Model: DDP70/92/184		Date: 30-Jan-06	No.: MG150001
Modified Article: Parts Catalog Correction		Prepared by: Y.Minakawa	
From: 2nd Tech. Support Sec. Service Support Dept.			
Reason for Modification:	<input checked="" type="checkbox"/> Parts catalog correction <input type="checkbox"/> Vendor change <input type="checkbox"/> Other <input type="checkbox"/> To facilitate assembly <input type="checkbox"/> To improve reliability <input type="checkbox"/> To meet standards <input type="checkbox"/> Part standardization <input type="checkbox"/> Product Safety ()

Model: DDP184		Date: 30-Jan-06	No.: MG150002
Modified Article: Parts Catalog Correction		Prepared by: Y.Minakawa	
From: 2nd Tech. Support Sec. Service Support Dept.			
Reason for Modification:	<input checked="" type="checkbox"/> Parts catalog correction <input type="checkbox"/> Vendor change <input type="checkbox"/> Other <input type="checkbox"/> To facilitate assembly <input type="checkbox"/> To improve reliability <input type="checkbox"/> To meet standards <input type="checkbox"/> Part standardization <input type="checkbox"/> Product Safety ()

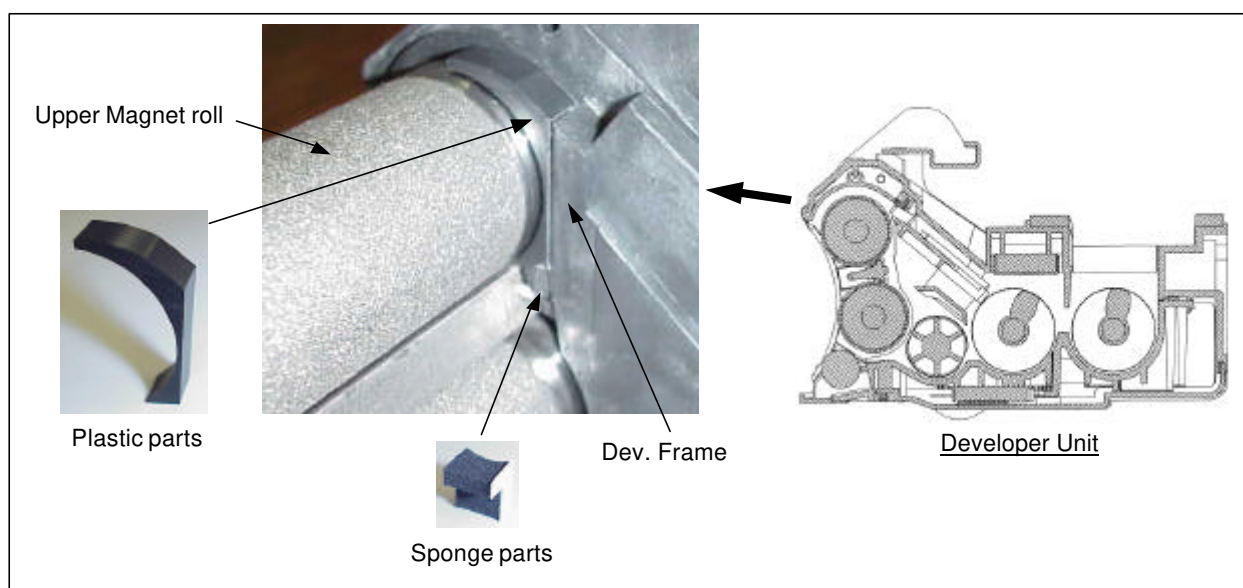
Plastic parts and sponge parts are attached between the Dev.frame and Upper magnet roll.
Applied to both ends of the Upper magnet roll.

To prevent developer mixture leaks.

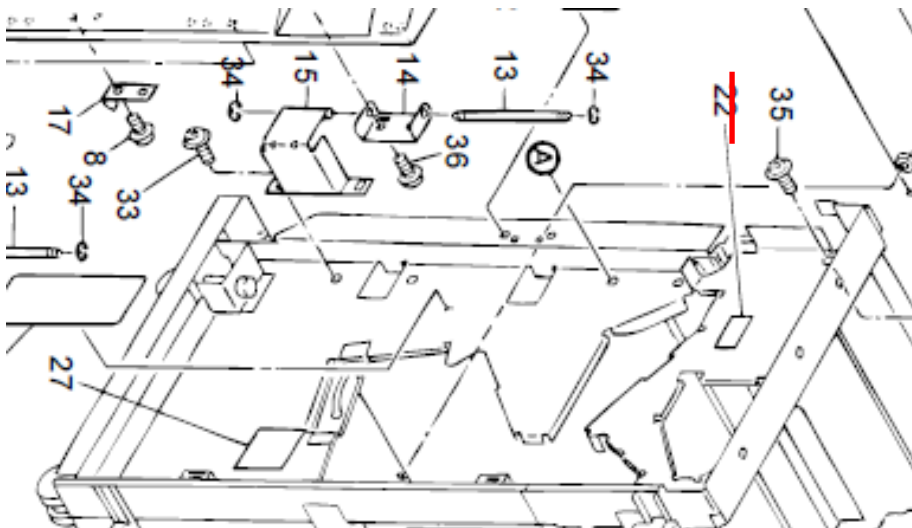
Change: This part has been deleted.

Reason: Label/A(G8501360) is not appropriate.

2. DDP92/184 Finisher

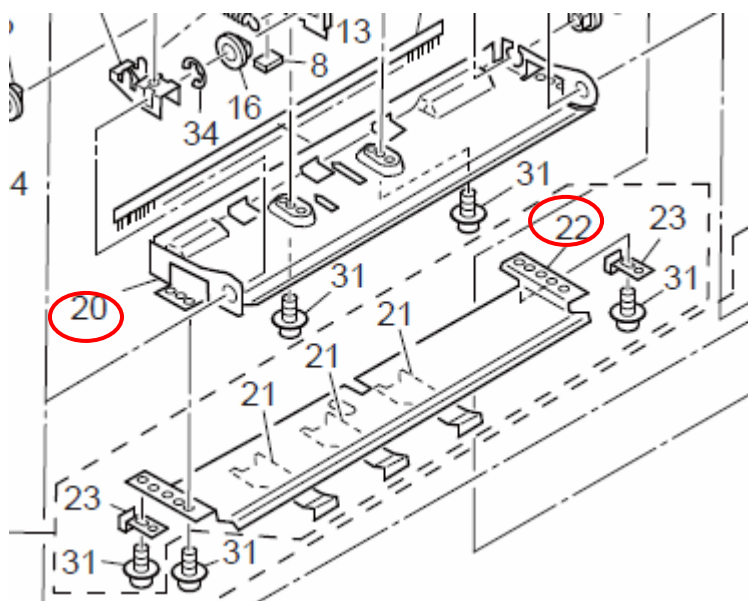
Change/Reason: Due to overlapping Ricoh P/Ns' for the same parts (Old P/N and New P/N), the old Ricoh P/Ns' have been removed.

Switch Cover Illustration

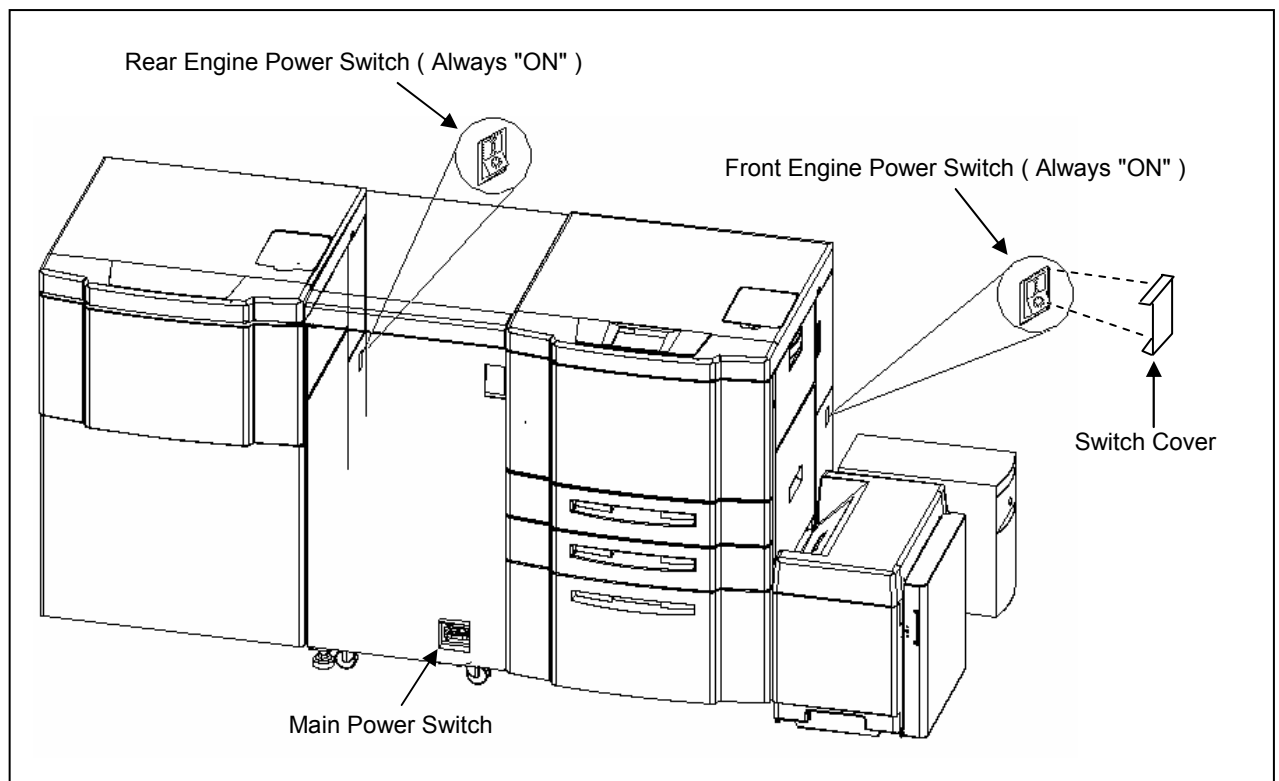
Attached the cover for the switch to the front engine to prevent false operation of the power supply switch.

G8581498 Belt Tension Plate

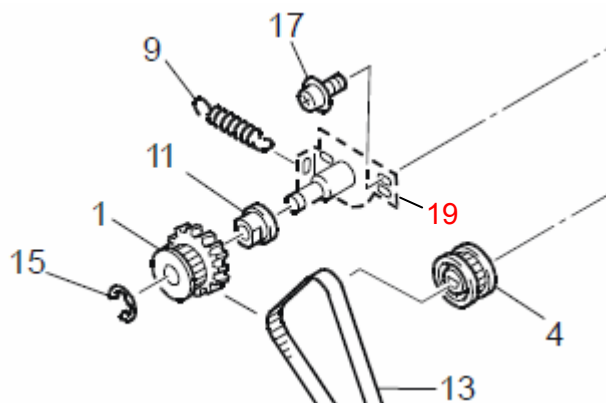
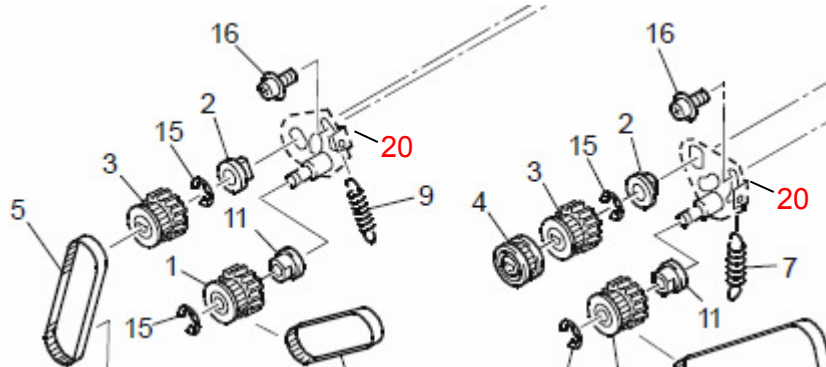
Change/Reason: New Parts are added to Finisher Parts Catalog.
